HEARING REPORT (VOLUME TWO)
WOODLANDS PARK ROAD / MANUKA ROAD,
WAIMA (TITIRANGI)
WATERCARE SERVICES LTD

Reporting on an application regional resource consents an a land use consent (NES Soil) for earthworks, vegetation removal and associated activities related to the Huia Replacement Water Treatment Plant. at Woodlands Park Road / Manuka Road, Waima (Titirangi). The reporting officer is recommending, subject to contrary or additional information being received at the hearing, that the application be **CONSENTED** to, subject to certain conditions.

To:	Richard Blakey, Consultant Planner
From:	Carl Tutt, Earthwork and Streamwork Specialist
Date:	10 December 2019

Figure 3.4: Geological section showing the escarpment located north of the Reservoir No. 1 site

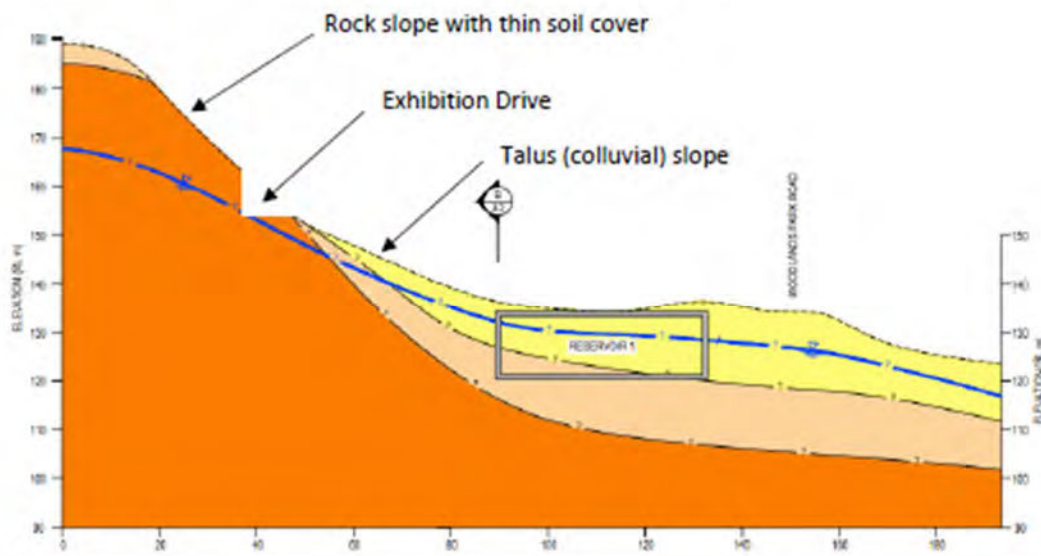
From stability consideration, T&T anticipates possible instability at Reservoir 1 could be either due to rock fall from the escarpment and/or failure of the existing colluvium soil. With potential rock fall, the issue is more to do with the asset protection and should be considered in actual building and structures design. For the colluvium soils, T&T did not identify any slope instability has occurred on the site, except for reporting some minor soil creep. T&T recommends that where earthworks are undertaken in the colluvium soils appropriate retaining structures will be required and these retaining structures will be designed and installed where the material is removed from the slope. Furthermore, it is proposed installing secant piles whilst undertaking excavation for Reservoir-1 to retain the cut faces.
